Proposed changes to London Luton Airport Arrivals

SAIP AD6 Supplement: Standard Terminal Arrival Routes – impact assessment of Instrument Flight Procedure technical amendment

Issue 1.0

Figure 1 STAR end and predicted hold entry as per ACP (above), proposed amendment (below)

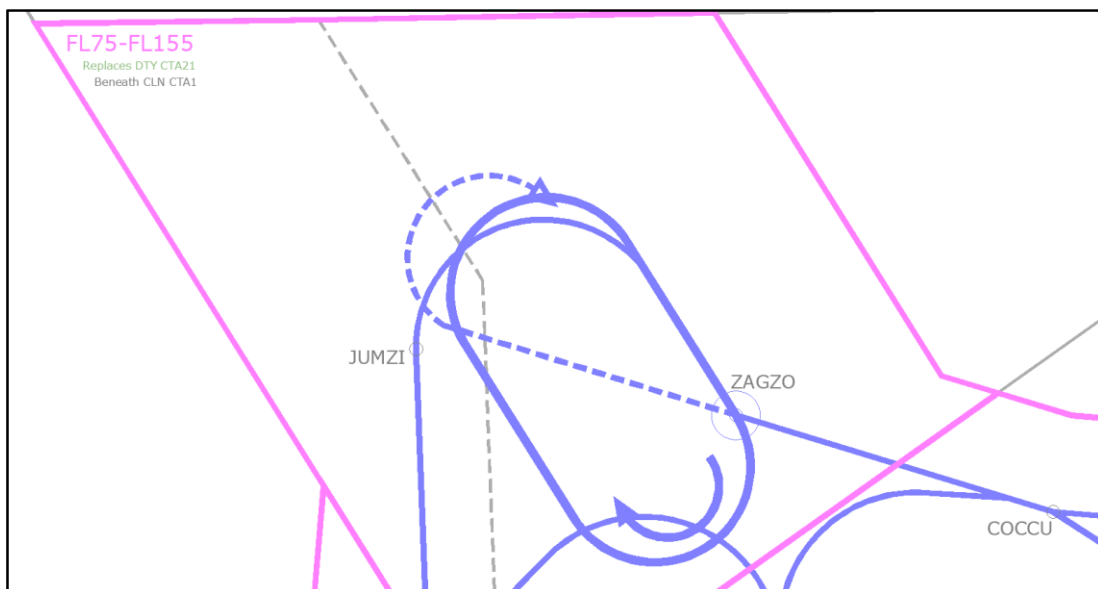
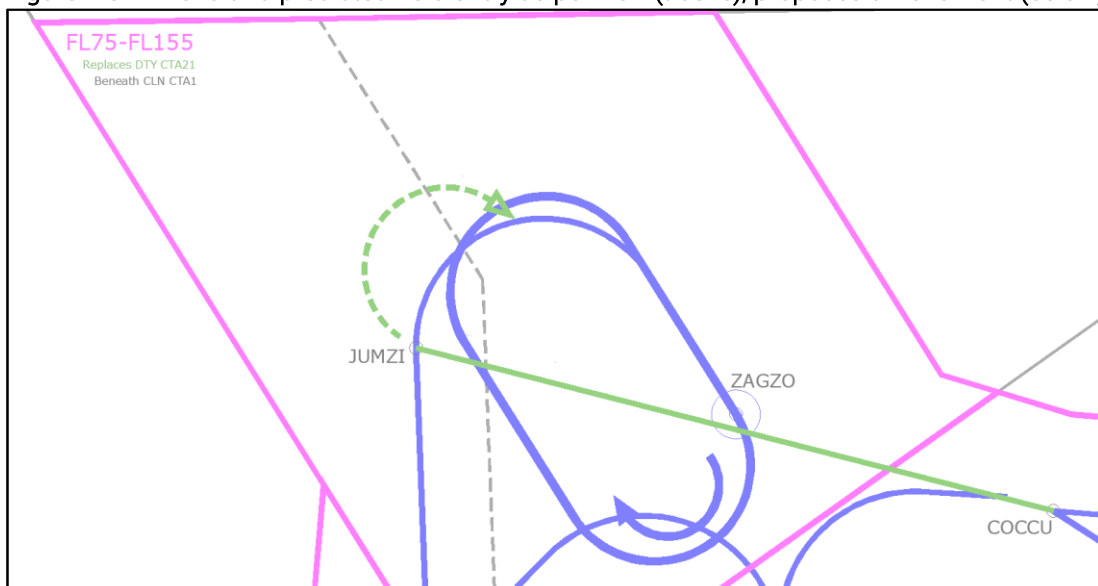
- 1.6 In Figure 1, the aircraft does not behave as predicted (upper diagram) under certain combinations of circumstances for the ACP design via waypoints COCCU-ZAGZO-Enter Hold.
- 1.7 Amending the STAR to route COCCU-JUMZI-ZAGZO-Enter Hold (lower diagram) would correct that unexpected behaviour. This may seem counter-intuitive, but the flight simulations using this amendment behaved as predicted, providing appropriate containment assurance. Technical material known as the Route Separation Analysis Document (which is commercially confidential) has been updated with an addendum, and has been supplied to the CAA privately.
- 1.8 This technical change is known as Design Option 1A-i.

- 3.1 We will amend the seven STARs listed in paragraph 1.2 above accordingly and request that the CAA considers them as part of this ACP.
- 3.2 There would be no measurable environmental impacts as a consequence.
- 3.3 Should the CAA decide to approve this proposal, and its supplements as Design Option 1A-i, implementation is planned for Thursday 24th February 2022.
- 3.4 An updated Technical Map, illustrating the amendments to the STARs, will be uploaded to the CAA's Airspace Change Portal at the same time as this document.
